UNITED STATES PATENT AND TRADEMARK OFFICE

| APPLICATION NO. | FILING DATE | FIRST NAMED INVENTOR | ATTORNEY DOCKET NO. | CONFIRMATION NO. |
|-----------------|-------------|----------------------|---------------------|------------------|
| 10/696,504 | 10/29/2003 | Tetsuya Kobayashi | 1324.68599 | 5768 |

Office Action Summary

DETAILED ACTION

Drawing 2

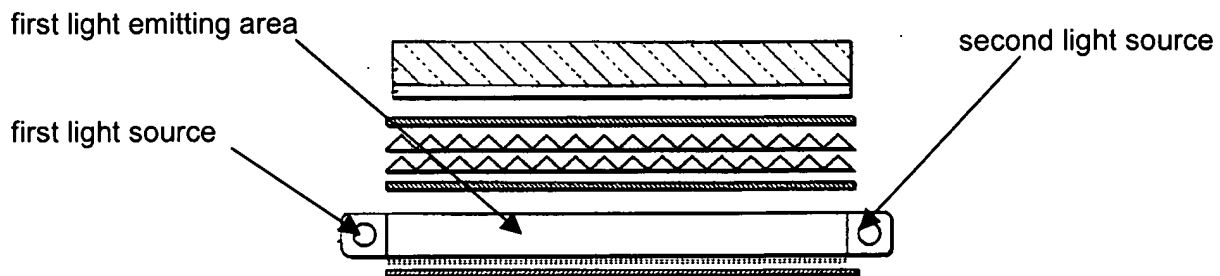
Hirakata [fig. 2a] teaches the illumination device comprising a first light source unit ("*light source unit 10*") including a first light guide plate ("*light guide 11*") and a first light source ("*fluorescent lamp 8*") disposed at an end thereof, for mainly illuminating a first light-emitting area [drawing 2 provided below, which is equivalent to fig. 2a of Hirakata] and a second light source unit.

Hirakata does teach a second light source unit laminated on the first light source.

Drawing 3

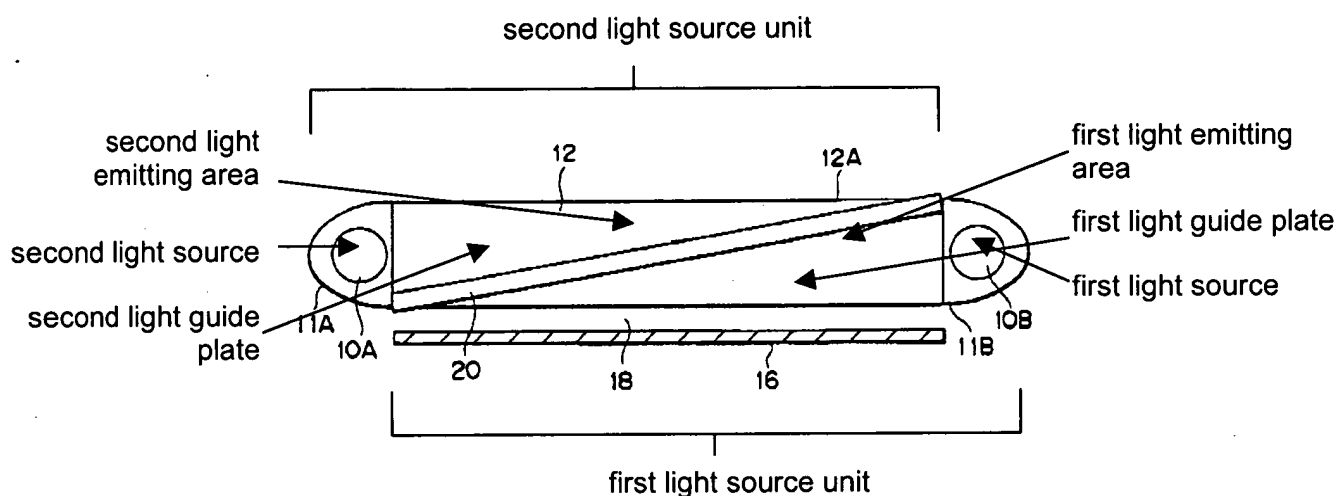
However, Hiyama [drawing 3 provided on page 6 of this office action, which is equivalent to fig. 9 of Hiyama] teaches an illumination device included in a liquid crystal display comprising:

a first light source unit including a first light guide plate and a first light source disposed at an end thereof, for mainly illuminating a first light-emitting area and supplying part of light to an adjacent second light-emitting area; and

a second light source unit laminated on the first light source unit and including a second light guide plate and a second light source disposed at an end thereof, for mainly illuminating the second light-emitting area and supplying part of light to the adjacent first light-emitting area.

It would have been obvious to one of ordinary skill in the art at the time of the invention to replace the illumination device of Hirakata with the illumination device of Hiyama such that the second light source of Hirakata is laminated on the first light source unit of Hirakata and the device of Hirakata includes a second light guide plate, as taught by Hirayama, in order to provide a light illumination apparatus of a liquid crystal display device with high light utility efficiency and uniformity [col. 2 lines 5-11].
